DEVIATION REQUEST AND DECISION FORM

Project Name : The Ridges at Lorson Ranch

Exhibit 1
Deviation Request Location
Ridges at Lorson Ranch (LSC #S214080)

Exhibit 2
Sight Distance Analysis
Grayling/Regan Ridge Dr.

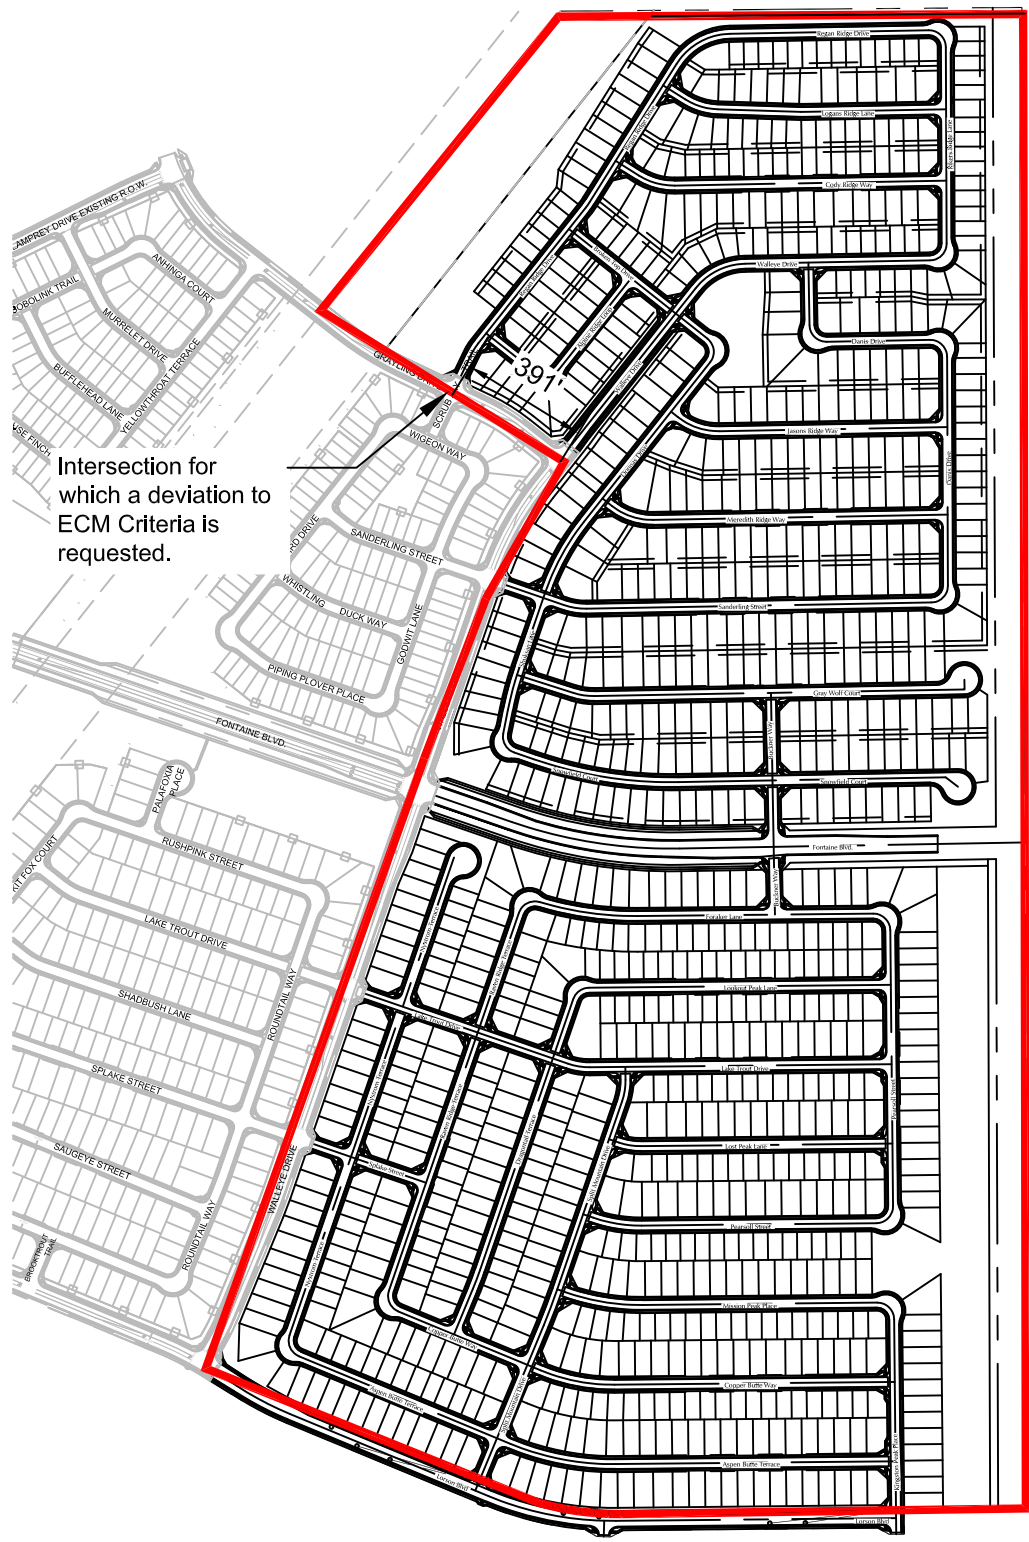
The intersection of Regan Ridge Drive/Grayling Drive is proposed about 391 feet east of Walleye Drive (centerline to centerline). As shown in **Exhibit 2** this configuration provides 356 feet of available intersection sight distance. This is 89 feet less than the *ECM* criteria.

The available intersection sight distance from Regan Ridge Drive/Grayling Drive to Walleye Drive is about 356 feet. The required intersection sight distance from Table 2-21 of the *ECM* is 445 feet, based on a design speed of 25 mph. As Grayling Drive/Walleye Drive is a "T" intersection, all westbound traffic on Grayling Drive approaching Regan Ridge Drive will have either just turned right or left from Walleye Drive. The turning speed for these movements is likely between 9 and 20 mph. The intersection sight distance requirement for a roadway with a posted speed limit of 25 miles per hour shown in Table 2-21 is 280 feet. Based on the lower travel speed, the 356 feet of available sight distance will be adequate

Address whether additional signage should be provided.

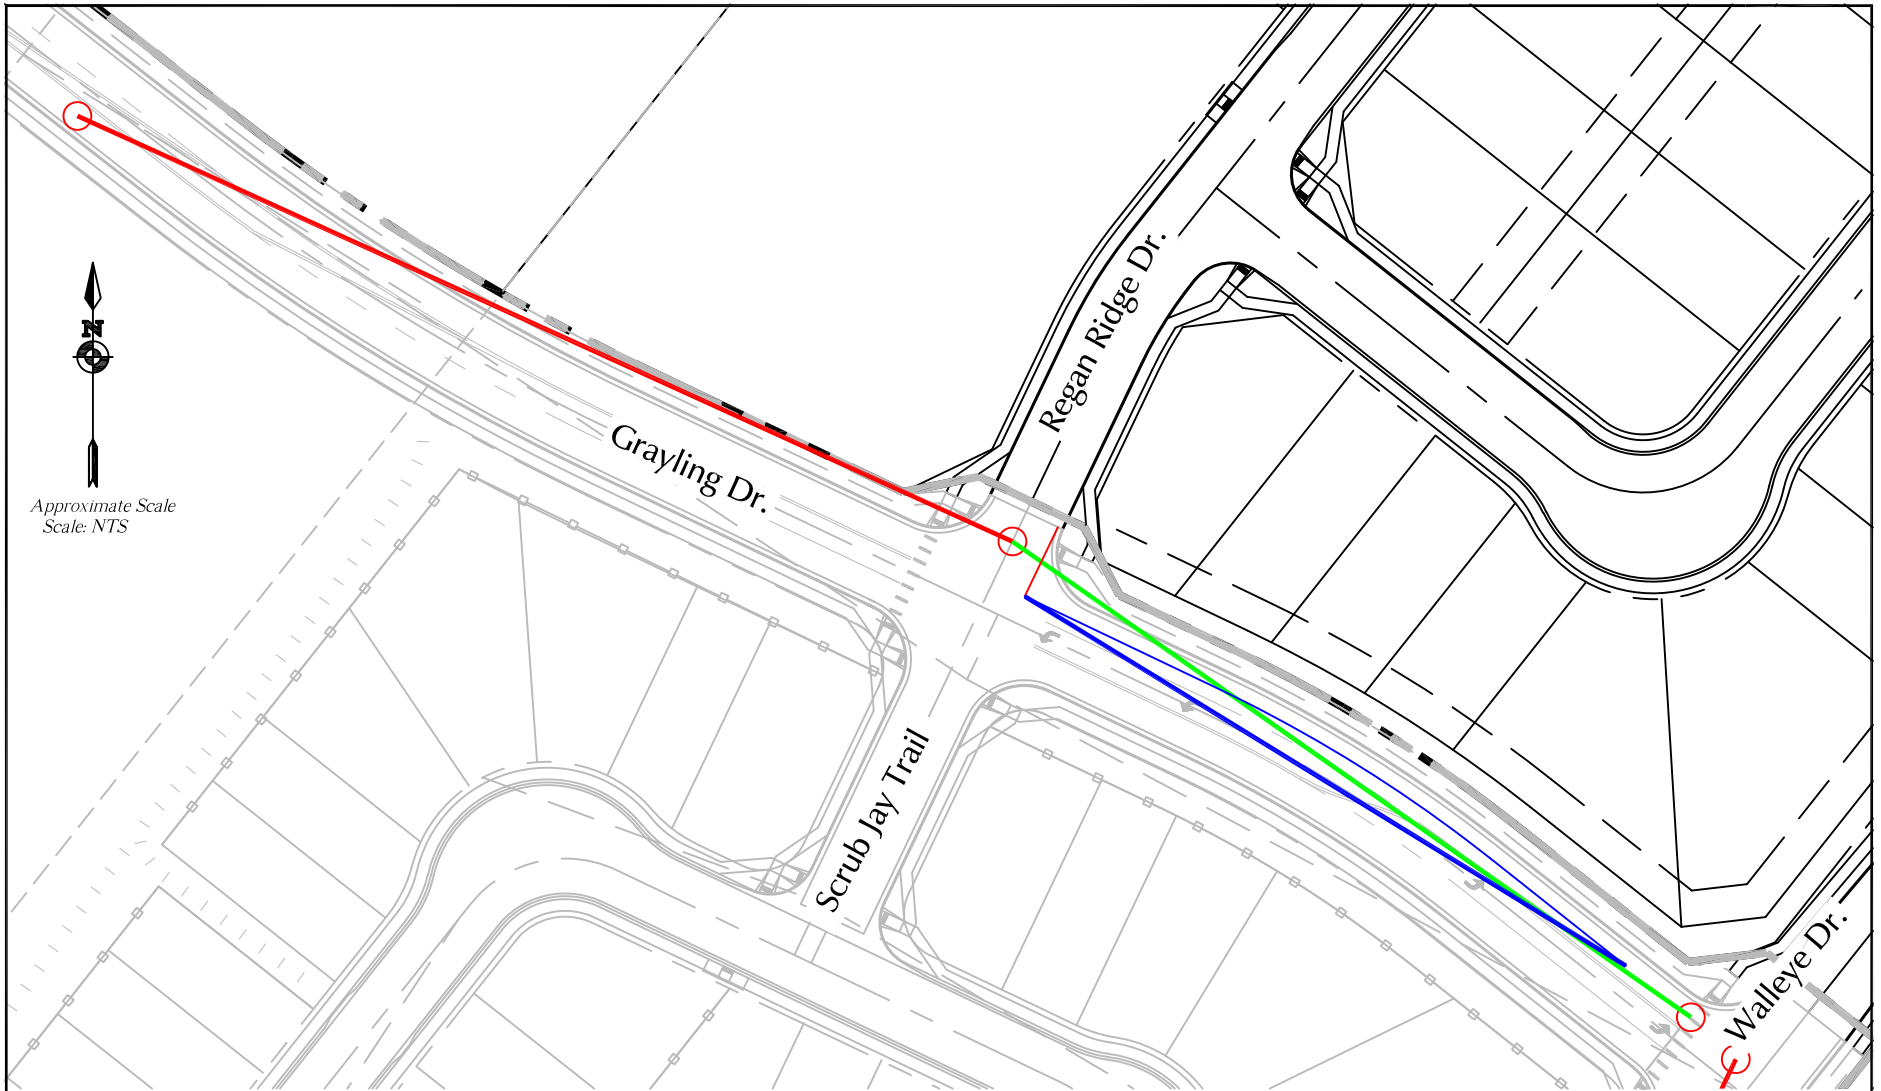
Exhibit 1 shows the location of the intersection (Regan Ridge Drive/Grayling Drive) for which the deviation is requested.

Intersection for which a deviation to ECM Criteria is requested.
